2022 Supplement to the VDOT 2020 Road and Bridge Specifications

This volume contains all revisions to the 2020 Road and Bridge Specifications effective December 31, 2021.

FIGURE III-10
Limits of Mainline Overlay at Intersections to Paved Roads

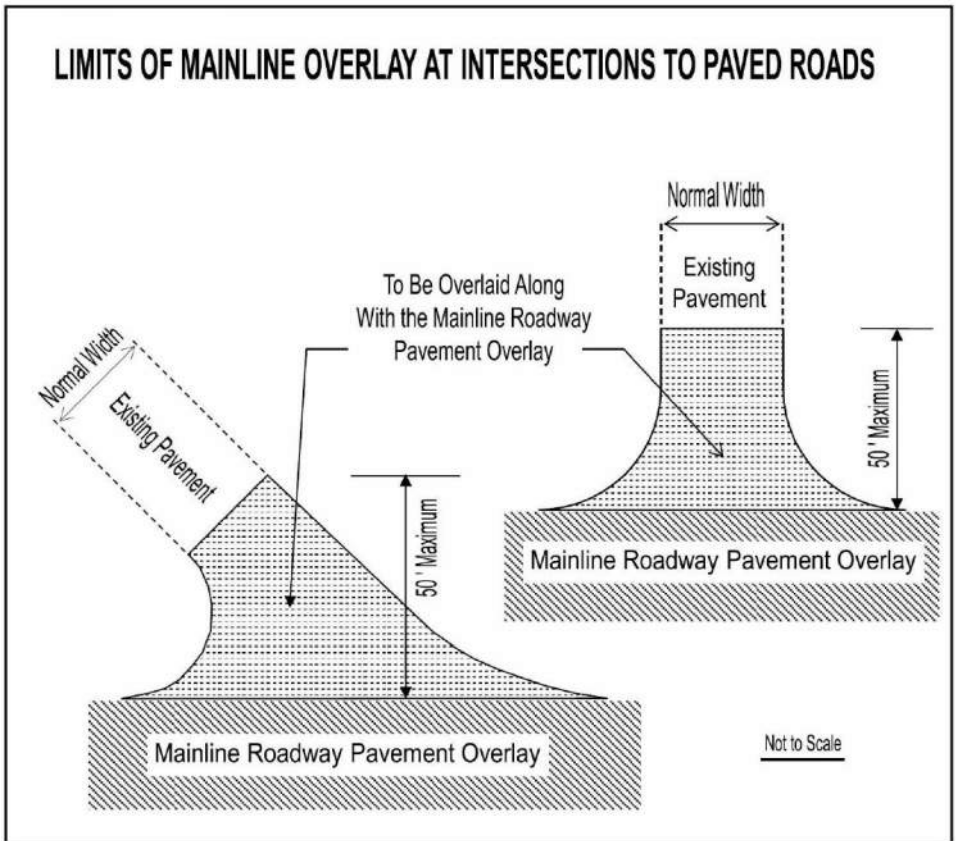
The Contractor shall overlay the intersecting paved road from the edge of pavement of the mainline roadway pavement overlay to a point that includes the entire radius of the intersecting paved road according to Figure III-10. This distance from the edge of pavement of the mainline roadway pavement overlay shall not exceed 50 feet measured according to Figure III-10.
